PIC16C73A Rev. A Silicon Errata Sheet

The PIC16C73A (Rev. A) parts you have received conform functionally to the Device Data Sheet (DS30390E), except for the anomalies described below.

FIGURE 1: SCK PULSE VARIATION USING TIMER2/2

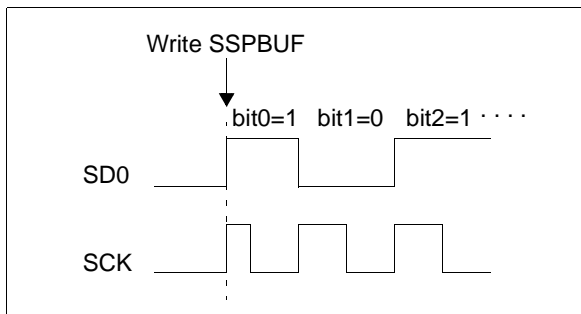
4. Module: SSP (SPI Mode)

When the SPI is using Timer2/2 as the clock source, a shorter than expected SCK pulse may occur on the first bit of the transmitted/received data (Figure 1).

Work around

To avoid producing the short pulse, turn off Timer2 and clear the TMR2 register, load the SSPBUF with the data to transmit, and then turn Timer2 back on. Refer to Example 1 for sample code.

FIGURE 1: WRITES TO TIMER1 (EXTERNAL CLOCK/OSCILLATOR MODE)

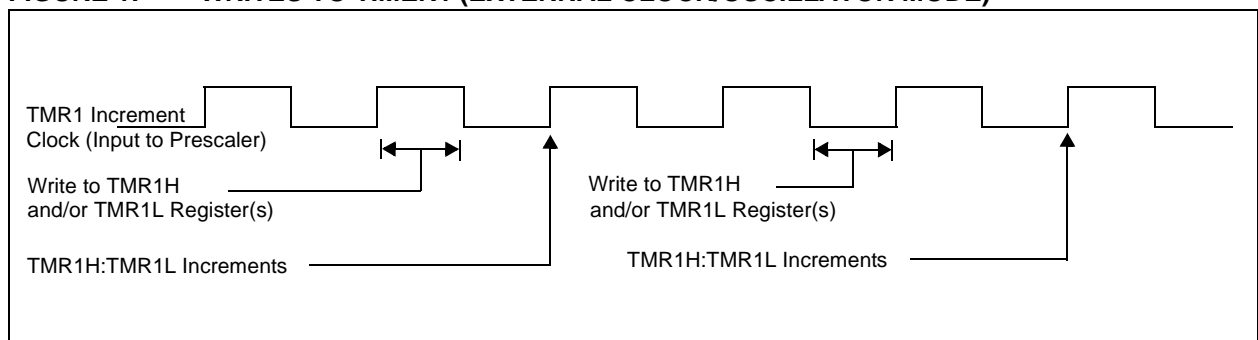
4. Module: Timer1

The operation of Timer1 needs some clarification when the timer registers are written when the TMR1ON bit is set.

The internal clock signal that is the input to the TMR1 prescaler affects the incrementing of Timer1 (TMR1H:TMR1L registers and the Timer1 prescaler). When the Timer1 registers are NOT written, the Timer1 will increment on the rising edge of the TMR1 increment clock.

When the TMR1H and/or TMR1L registers are written while this clock is high, TMR1 will increment on the next rising edge of this clock.

When the TMR1H and/or TMR1L registers are written while this clock is low, TMR1 will not increment on the next rising edge of this clock, but must first have a falling clock and the rising clock, for TMR1 to increment.

Figure 1 shows the two cases of writes to the TMR1H and/or TMR1L registers. Due to the V_{IH} and V_{IL} thresholds on the oscillator/clock pins, external Timer1 oscillator components, and external clock frequency, the Timer1 increment clock may not be of a 50% duty cycle.

The TMR1 increment clock is out of phase of the T1OSO/T1CKI pin by a small propagation delay.
